GB ENERGY PARK HOLDINGS LLC

RE: UTC Docket Nos UE-200304 - Comments of GB Energy Park Holdings, LLC with Respect to The 2021 Puget Sound Energy Final Integrated Resource Plan

Figure 2: 100MW Addition of 8-hour Pumped Storage ELCC Value by PNW Utility

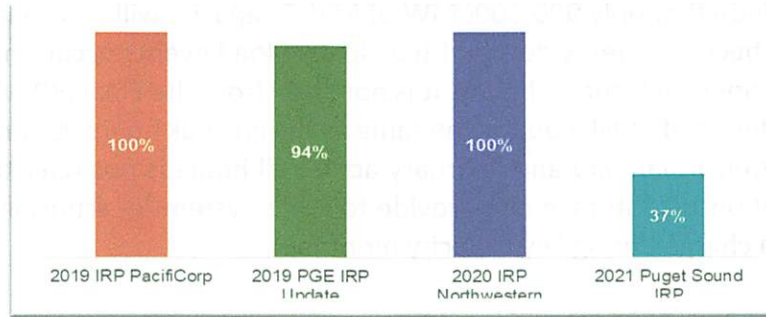
Resource adequacy modeling assumptions utilized in PSE’s Final IRP resulted in effective load carrying contribution (ELCC) values for battery storage and pumped storage that are significantly lower than ELCC values reported by other Pacific Northwest load serving entities (LSEs). Figures 2 and 3 below present the reported ELCC value of 100MW of 4-hour battery storage and 100MW of 8 hour pumped hydro across several PNW LSEs.^{5 6 7 8} Figure 2 below illustrates, a 100MW 8-hour addition of pumped hydro storage was given a 37.2% ELCC in PSE’s Final IRP which is about three times lower than the ELCCs assessed by LSEs of similar size in the region. Similarly in Figure 3, a 100MW 4-hour addition of battery storage was given a 24.8% ELCC by PSE, which is 3 to 4 times less than the ELCCs of other PNW LSEs.

The low stand-alone storage ELCC values in PSE’s Final IRP suggest that storage facilities are not being given the opportunity to charge prior to key capacity service hours. Both pumped storage and batteries are incredibly flexible assets that can ramp up within seconds to provide needed capacity in potential loss of load events. Utility operators can optimally schedule the charging of energy storage to ensure that the dispatchable asset has a full charge ahead of any forecasted peak demand events. For a pumped hydro asset with 8 hours of duration, charging during PSE’s off-peak hours -- in the night and the middle of the day -- would be enough to ensure that all morning and afternoon peak hours are covered. The low stand-alone storage ELCC values suggest PSE’s system does not have sufficient energy from its existing portfolio or from the market to charge energy storage prior to forecasted peak load events in the winter, even during off peak hours.

As discussed above, the Final IRP presents energy storage ELCC that are considerably lower than other PNW utilities, most likely driven by PSE's market import assumptions. GBEP recommends that PSE revisit the Final IRP Mid-C import assumptions to ensure that the utility is not artificially limiting imports across all hours. Historically there have been little to no capacity deficits during off-peak hours in January and February. Artificially limiting imports during off-peak hours negatively impacts the ELCC value of energy storage and deflates the value that these resources can provide to the PSE's system. GBEP also recommends that PSE carefully consider the ELCC value of storage when paired with renewable resources, particularly during the 2021 PSE All Resource RFP process.

Figure 4: PSE Base Case 2027 Loss of Load Events

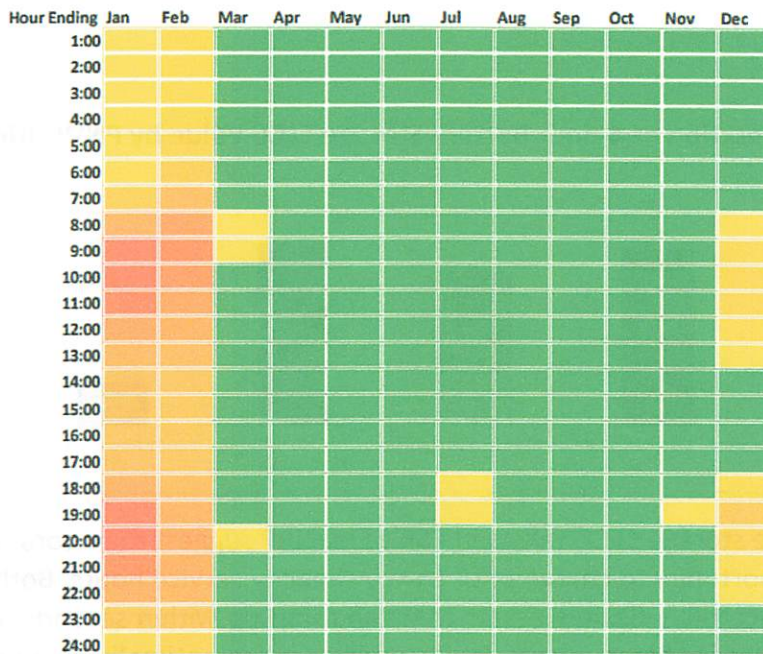
Driving PSE’s system energy deficiency in 2027 winter months is the assumption PSE makes related to Mid-C market purchases. A key assumption in PSE’s resource adequacy modeling is the amount of Mid-C market purchases available during peak load events in the winter. PSE owns 1,500MW of Mid-C transmission for imports, however, for any given month and hour the amount

of market capacity available for purchase may vary.⁹ For January and February, PSE’s market simulations conclude that only 900-1000MW of Mid-C capacity will be available. As a result, the 2027 PSE system become energy deficient (i.e., loss-of load events occur) in all hours of January and February as shown in Figure 4 below. It is not clear from the Final IRP whether the assumed market capacity during off peak hours is the same as the on peak hours. Assuming that the market is limited by 500MW in January and February across all hours is not realistic and penalizes the capacity contribution that storage can provide to PSE’s system by artificially limiting the hours when storage can charge during key capacity months.

- 4- Ensure that modeled ELCC values for stand-alone storage are not utilizing winter peak Mid-C import assumptions year-round, and thereby reflecting an inaccurate shortage of energy availability for charging.

Figure 6: PSE Net Levelized Cost of Energy Storage

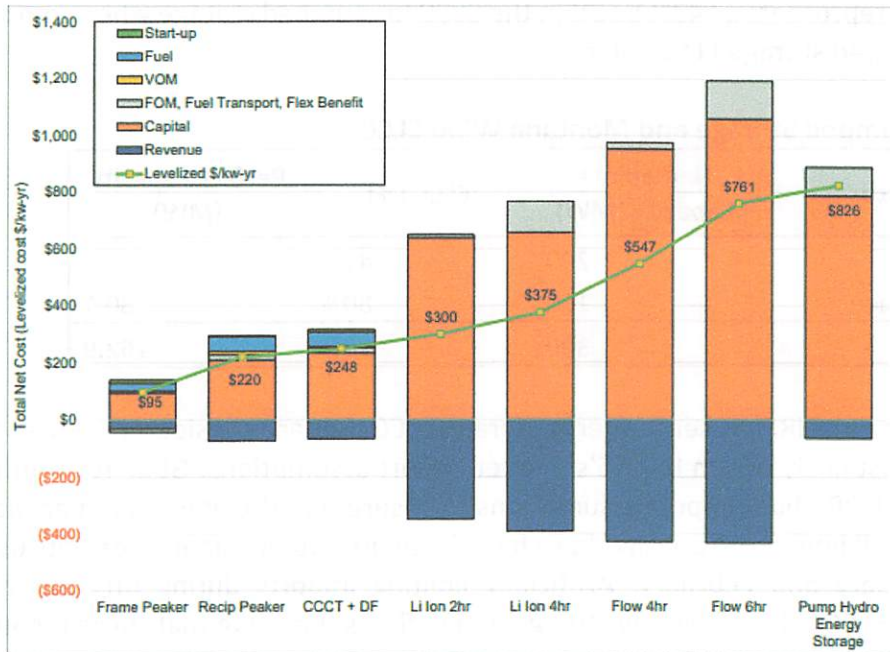
PSE's Final IRP shows an extremely high net levelized cost for pumped storage, driven by low ELCCs, incredibly low revenues, and inaccurate pumped storage operating constraints. As shown in Figure 6 below, the net levelized cost of all energy storage systems exceed the net levelized cost of peakers and combined cycle natural gas plants. Driving the net levelized cost extremely high is the low stand-alone ELCC values that PSE attributes to energy storage. For pumped storage specifically, the net levelized capital cost is estimated to be ~\$800/kw-year after adjusting for the 37.2% ELCC. If the ELCC for pumped storage were to be closer to 90%, the net cost of capital would be \$330/kw-year, a 58% reduction in net levelized capital cost. A similar calculation can be performed for all energy storage technologies, showcasing the extreme net levelized costs that result due to PSE's low ELCC values for standalone storage.

Particularly concerning for GBEP is the low revenue assumed for pumped storage when compared to the extremely high revenue associated with other storage technologies. For example, in Figure 6, the net revenues assumed for a six-hour duration flow battery totaled around \$430/kw-year. It is unclear if PSE is adjusting revenues based on ELCC, but \$430/kw-year in revenue is not aligned with any of the revenue values documents by PSE in the Final IRP. For a 6-hour flow battery the sum of flexibility benefits (\$23.24/kW-year) and transmission and distribution deferral benefits (\$12.54/kW-year) is only \$35.8/kW-year.^{11 12} This implies that the energy value and other benefits for a 6-hour flow battery must total \$394.2/kW-year, which is extremely high. The total revenue assumed for pumped storage in Figure 6 is only ~\$60/kW-year, which is only 14% the revenue of the 6-hour flow battery. Given that pumped hydro has similar ramping capabilities, a superior charging efficiency (80%) and more duration (8hrs) it does not fundamentally make sense why the flow battery revenue is so much higher.

Underlying the low revenue and ELCC results discussed above is PSE’s IRP assumption that pumped storage must have a 30% minimum state of charge. By constraining the pumped hydro state of charge to a 30% minimum, this assumption effectively transforms eight hours of duration into 5 and a half hours of duration. There is no operational rationale for why the pumped storage

could not go below 30% state of charge if required or economic. The 30% minimum state of charge operational assumption only further negatively impacts the economic outlook of pumped storage.

GBEP recommends that PSE reperform the net levelized cost of storage analysis with refreshed storage ELCCs and updated operational parameters for pumped hydro. In particular, PSE must address why such a significant revenue gap exists between pumped hydro and other storage technologies prior to issuing the 2021 All Resource RFP. If not addressed, pumped storage assets will not be fairly considered and evaluated.
